**6. COA-050416-2019**

# Commission of Architectural Review

## STAFF REPORT

**Convert second story window into a door and install a fire escape.**

Figure 3. 200 West Marshall Street, rear section and location of proposed fire escape stairs.

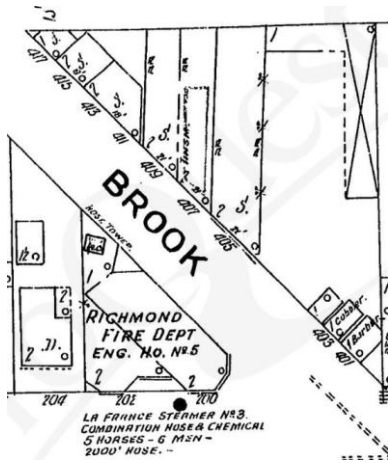
- The new stairs be installed in a manner that does not damage the historic masonry, so that should they

be removed in future the material integrity will not be diminished.

- The new door be submitted to staff for review and approval.
- The historic window be retained for future use.
- A revised elevation that accurately reflects the existing and proposed opening be submitted to staff.
